## **Westfield Penrith Access Report 3**

This Access Australia (AA) Access Report relates to instructions and documents received to date from Scentre Group / Westfield regarding tenancy shop 152 at the Westfield Penrith Shopping Centre, Penrith NSW.

## Proposed tenancy    Shop 152

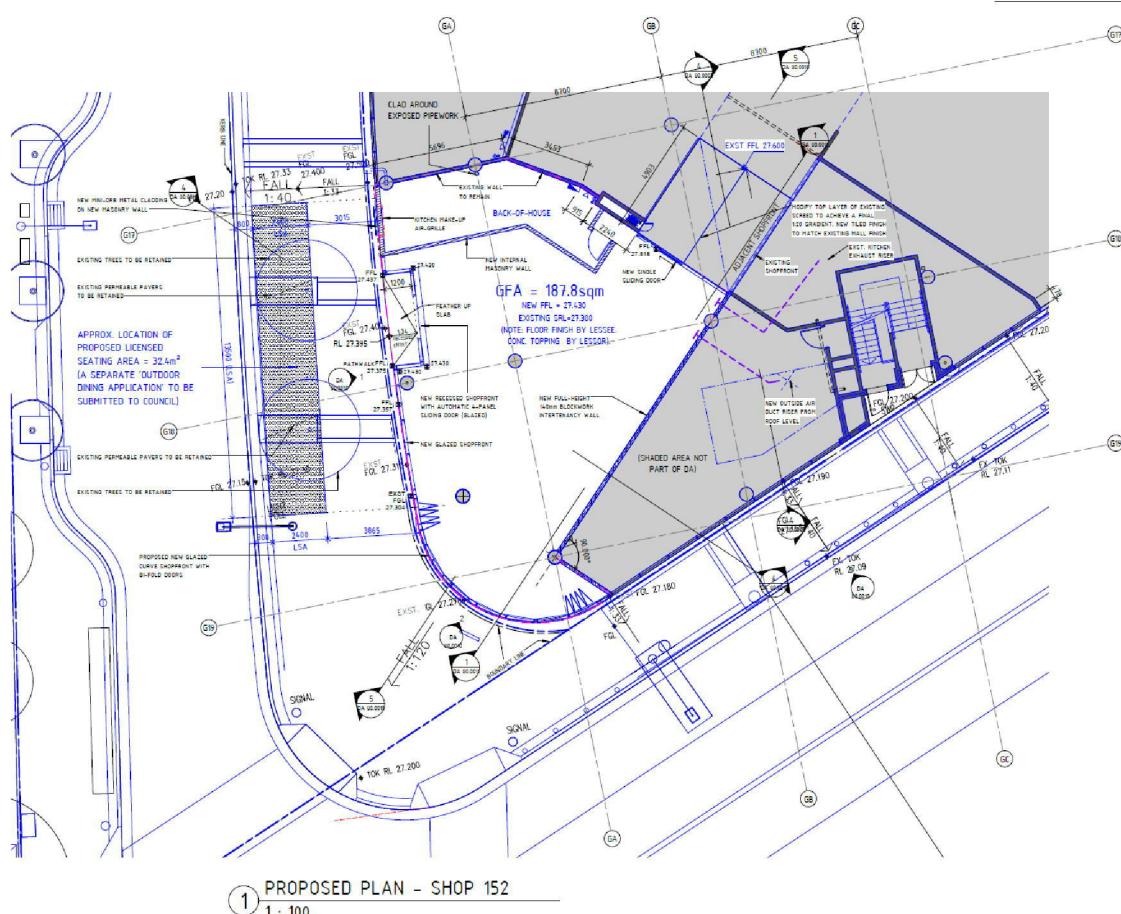
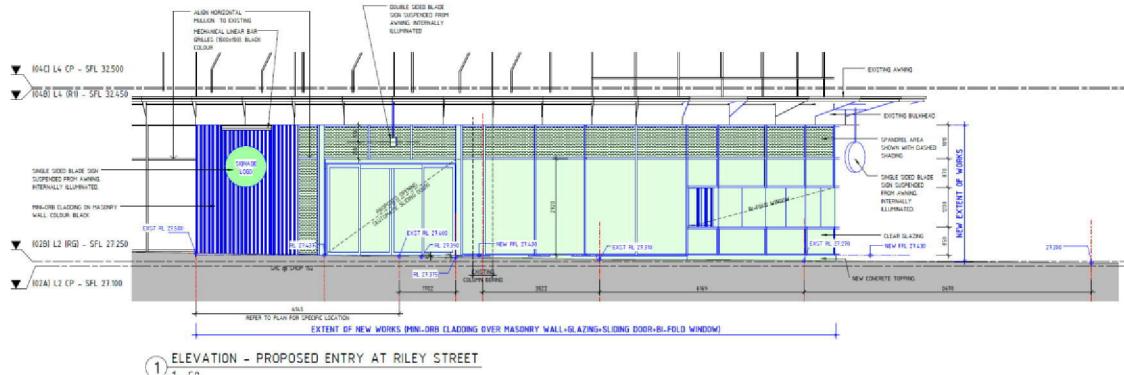
The proposal is to close the SE Riley / Henry St pedestrian entry and convert the existing Laser Clinics Australia tenancy to a restaurant with outdoor seating.

The proposed tenancy will include increased floor area utilising the closed entry area together with new external façade cladding and new licensed seating area to the Riley St frontage including new moveable planter boxes and fixed benches.

A 1200mm± recessed entry to shop 152 with 1:34± gradient landing is provided at the Riley St frontage.

AA recommends closure of the Riley / Henry St pedestrian entry and utilisation of the area for retail purposes subject to

- ❖ Accessible entry to and within the new tenancy
- ❖ Accessible fixture, fittings and equipment within the new tenancy

Riley St frontage      Shop 152 outdoor dining, footpath and entry

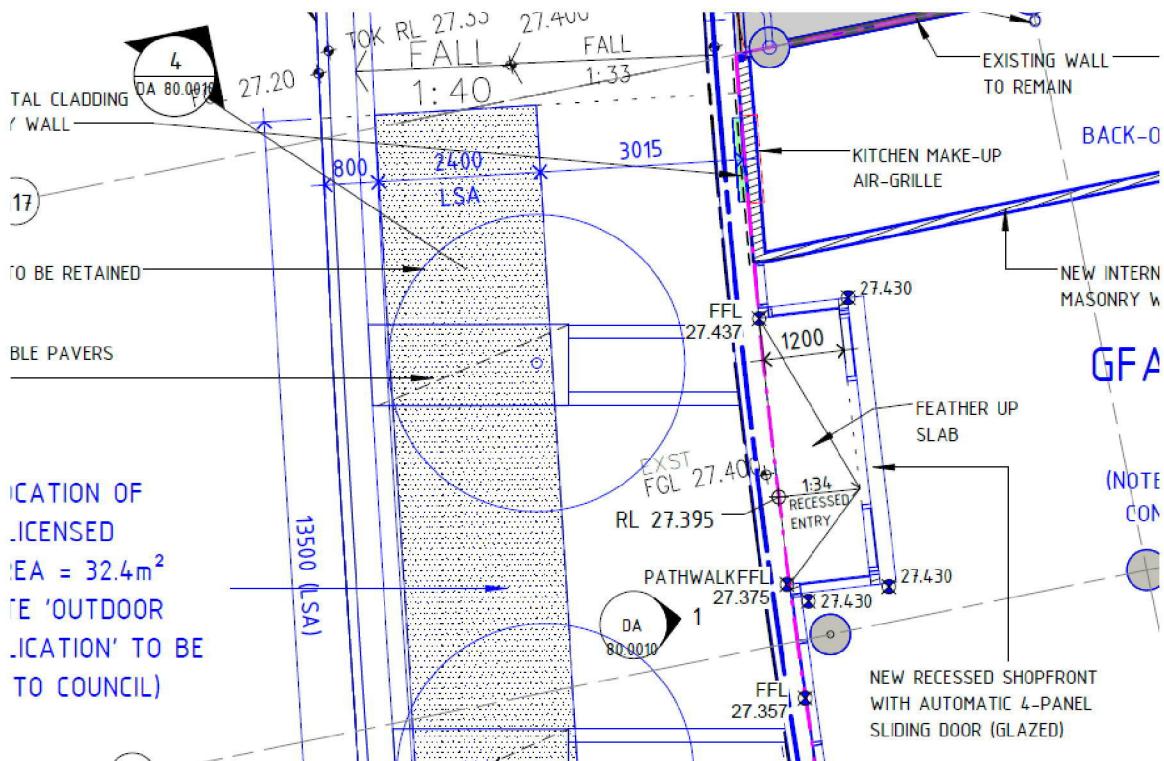
The proposed outdoor dining area is  $2400\pm$  wide with resultant  $3m\pm$  wide footpath to Shop 152 Riley St frontage.

The  $1200mm\pm$  recessed entry to shop 152 is via a complying  $1:34\pm$  gradient landing and automatic sliding doors at the Riley St frontage.
